# Babcock & Wilcox

Nuclear Power Generation Division

The attached report contains our responses to the Notice of Nonconformance identified in NRC Inspection Report 99900400/82-02.

B&W-NPGD RESPONSE TO NRC INSPECTION REPORT NO. 99900400/82-02

EXHIBIT A

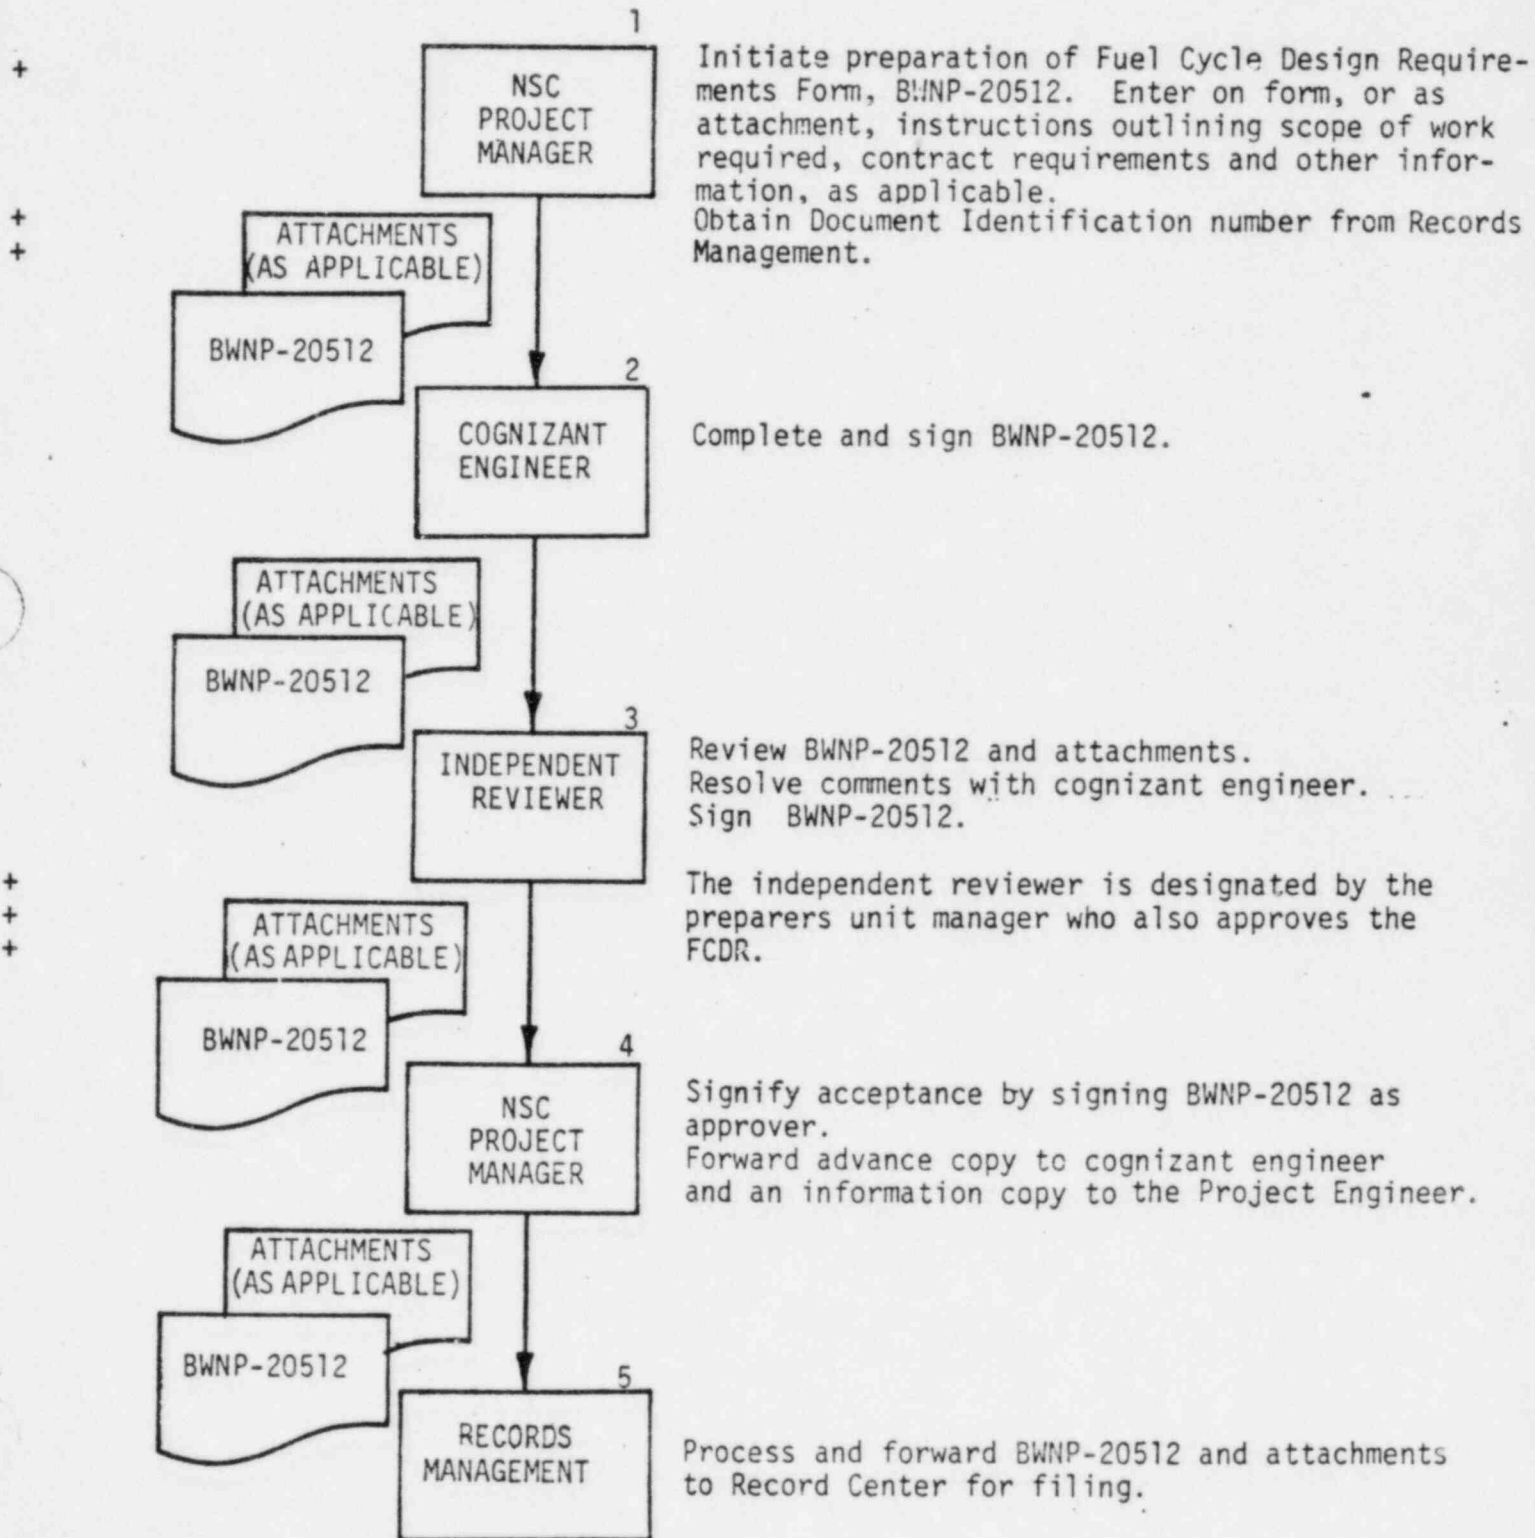
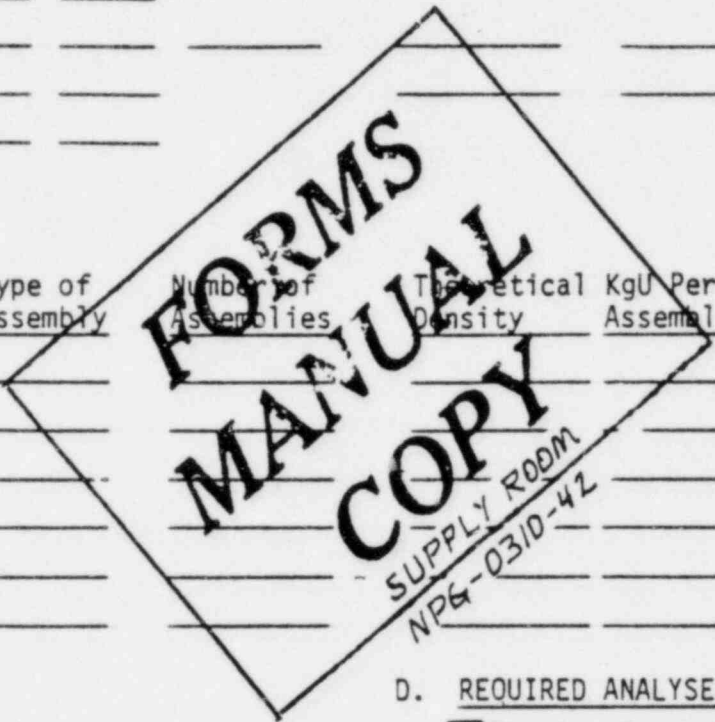
Section VI.A and Exhibit A of Nuclear Power Generation Division (NPGD) procedure NPG-0310-42, "Preparing and Processing Fuel Cycle Design Requirements" states in part, "The Fuel Cycle Design Requirements (FCDR) list contractual requirements. . . which relate to design, capability, and description of the reload core . . . (the) Nuclear Steam Core (NSC) Project Manager . . . originate(s) Fuel Cycle Design Requirements Form, BWNP-20512. Enter(s) on form . . . information, as applicable . . . Sign(s) form . . ."

Contrary to the above, the NSC Project Manager for the Sacramento Municipal Utility District (SMUD) Rancho Seco Project did not originate FCDR 89-1127000-01, enter applicable information on the FCDR, nor sign the FCDR for fuel reload cycle 6.

With respect to Nonconformance A, B&W revised and reissued Fuel Cycle Design Requirement 89-112700-01 to include the required signatures, determined that this was an isolated case, and committed to revise procedure NPG-0310-42 to clarify the preparation and signature requirements and to revise the format and content of the form on which the design requirements are listed, by August 1, 1982

Procedure NPG-0310-42 and the FCDR Form were revised and released to the Administrative Manuals on July 1, 1982. (Refer to Exhibit I).
